DEPARTMENT OF THE NAVY
NAVAL FACILITIES ENGINEERING SYSTEMS COMMAND PACIFIC
258 MAKALAPA DR STE 100
PEARL HARBOR HI 96860-3134

Notice No. 5
9 April 2026

PRE-PROPOSAL QUESTIONS & ANSWERS

RFP N62742-26-R-1300
WON 1665555, FY24 AJJY183012 (P-012), PDI: NORTH AIRCRAFT PARKING RAMP,
ANDERSEN AIR FORCE BASE, GUAM

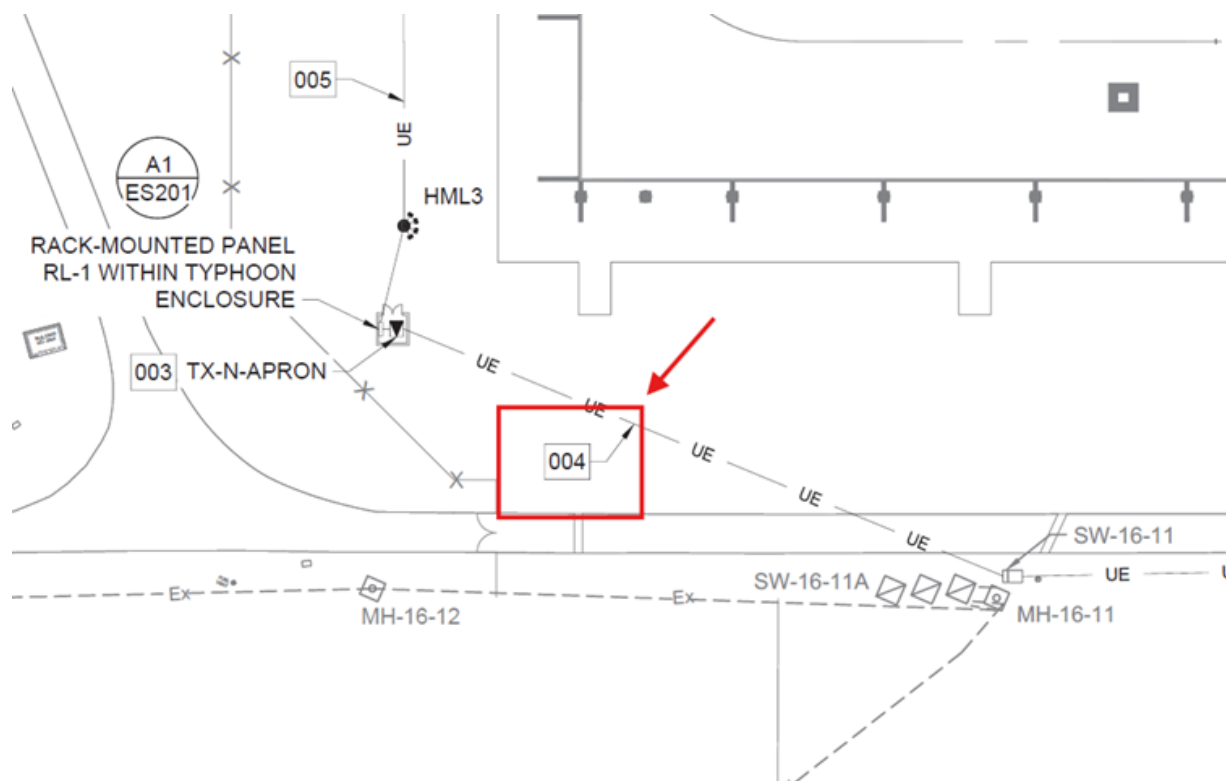
47. Drawing CG146 called out drawing CG145 for Sinkhole repair methodology. Refer to the excerpt note shown below
".....THE METHODOLOGY MUST BE BASED ON AND INDICATE THE REPAIR TYPE ZONE SHOWN ON CG144 AND CG145 THAT IS REQUIRED TO GUARANTEE THE PROJECT'S DESIGN".
Drawing CG145 is missing in the drawing package and SHEET INDEX listed CG145 as "NOT USED".

Question: Provide a copy of CG145 drawing?

ANSWER: There is no Sheet CG145. The note on Sheet CG146 will be corrected in a forthcoming amendment.
